Commonwealth Edison

June 20, 1984

Subject: Byron Generating Station Units 1 and 2
Technical Specifications
NRC Docket Nos. 50-454 and 50-455

This is to provide additional comments and suggestions regarding the proof and review version of the Byron 1 Technical Specifications that was distributed in reference (a). NRC review of the specific changes proposed here is necessary before the Technical Specifications can be finalized.

Figure 3.2-3 N-loop Operation vs. F_{OH} Limit
RCS Total Flow Rate vs. R

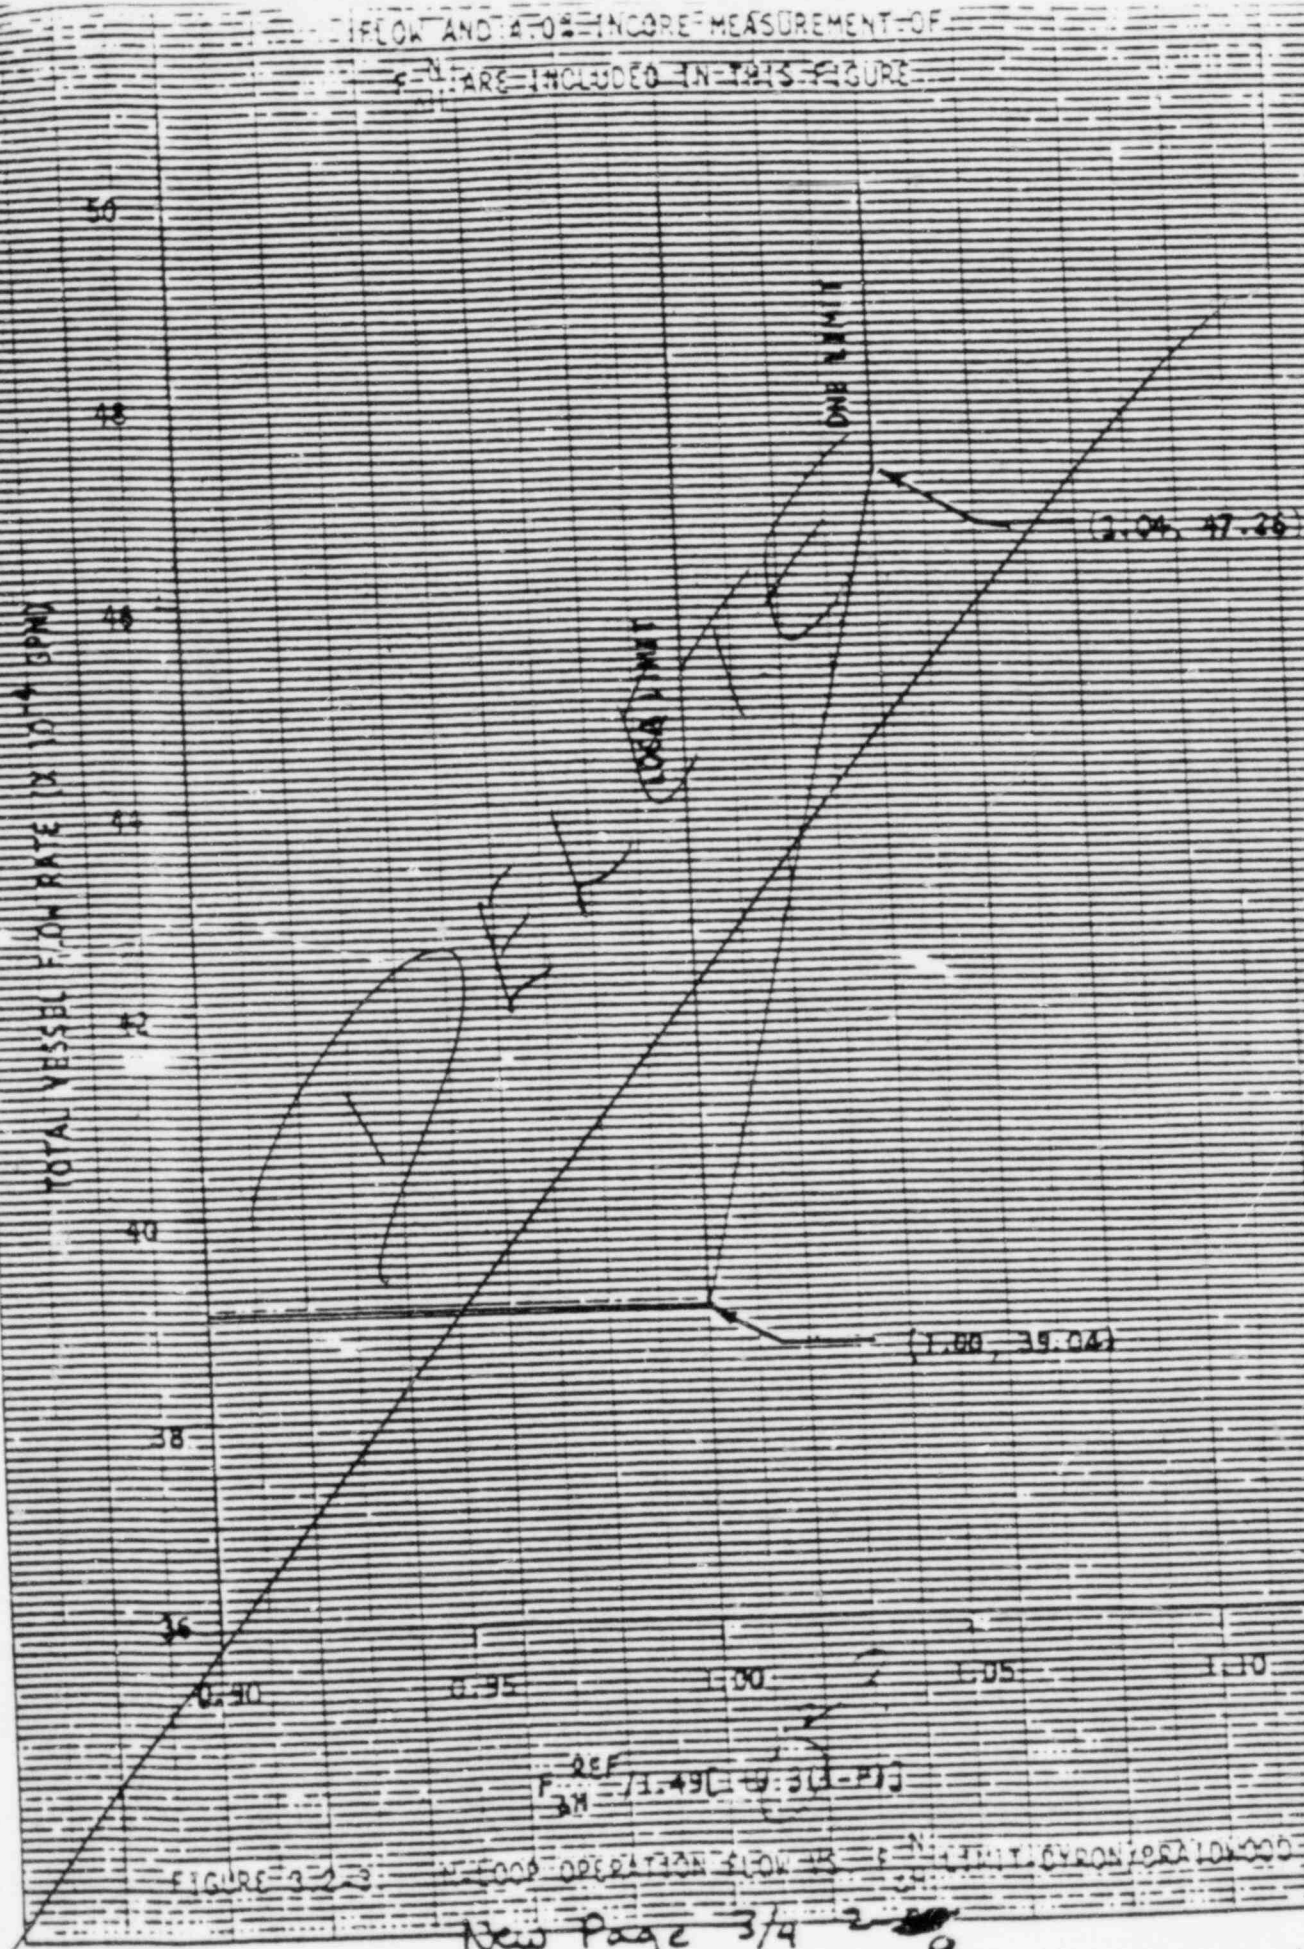
Delete "shown on Figure 3.2-3".

Delete Figure 3.2-3

Since there is no rod bow penalty, Figure 3.2-3 (pg. 3/4 2-9) could be simplified and described by a rectangle. The proposed change to the LCO Section 3.2.3 incorporates the requirements of Figure 3.2-3; therefore, the figure we've previously submitted can be deleted.

With the elimination of Rod Bow Penalty, all references to R can be deleted. The proposed changes define $F_{\Delta}^N H$ directly without using a ratio.

2.3 Indicated Reactor Coolant System (RCS) total flow rate and $F_{\Delta H}^N$ shall be maintained as follows for four loop operation.

a. RCS Total Flowrate $\geq 386,000$ GPM

b. $F_{\Delta H}^N \leq 1.55 [1.0 + 0.3(1.0 - P)]$
